Service Bulletin Number: SB-AG-34

5 August 1993 REVISED 6 DECEMBER 93

FUSELAGE-WING ATTACH TUBE BEEF-UP

ing of Wing Attach Fitting Beef-Up

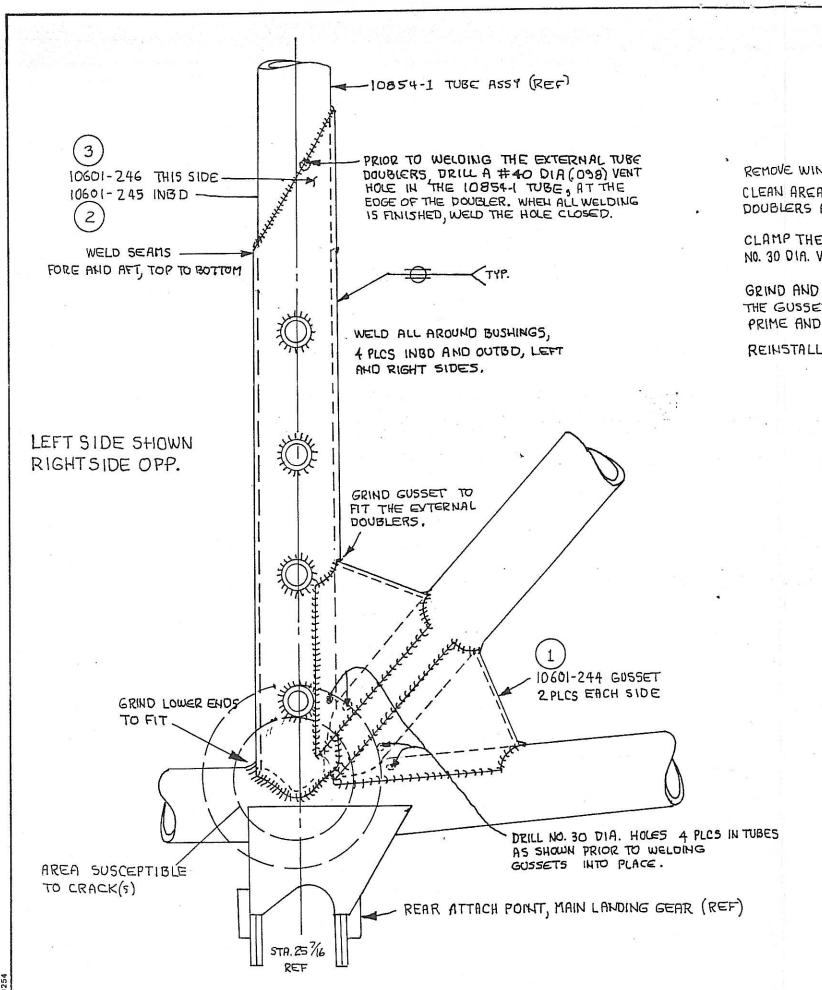
- 1. Remove fuselage side skins to gain access to the wing main spar attach angles, remove landing gear area skins underneath the airplane.
- 2. With flashlight and mirror, inspect the areas shown in the drawing SB-AG-34-1 in this bulletin. The area is very-difficult to see, so great care must be taken to thoroughly inspect all around the weld cluster. If there is any doubt about the appearance, or suspicion of a crack partially hidden by the wing attach angles, remove them for better access, perform dye penetrant check.
- 3. If the inspection reveals a crack, compliance is required before the next flight, see drawing SB-AG-34-1.

REMOVE WINGS AND WING ATTACH ANGLES.

CLEAN AREA THOROUGHLY, AND REMOVE PAINT FROM AREAS TO BE WELDED. FIT THE EXTERNAL TUBE DOUBLERS AT THE BOTTOM BY GRINDING AS REQD TO MATCH THE CLUSTER TUBES.

CLAMP THE -245 AND -246 IN PLACE AND DRILL # 40 DIA VENT HOLE AS SHOWN. DRILL THE 4 EACH NO. 30 DIA. VENT HOLES IN THE CLUSTER TUBES AS SHOWN. WELD THE DOUBLERS COMPLETELY, EXCEPT UPPER VENT.

GRIND AND FIT THE -244 GUSSET AT THE FRONT TO MATCH THE EXTERNAL DOUBLER RADIUS. WELD THE GUSSETS INTO PLACE. WELD THE VENT HOLE AT TOP CLOSED. WIREBRUSH, SAND AND CLEAN THE REPAIR. PRIME AND PAINT.

REINSTALL WINGS, RECORD COMPLIANCE IN AIRCRAFT LOG BOOKS.
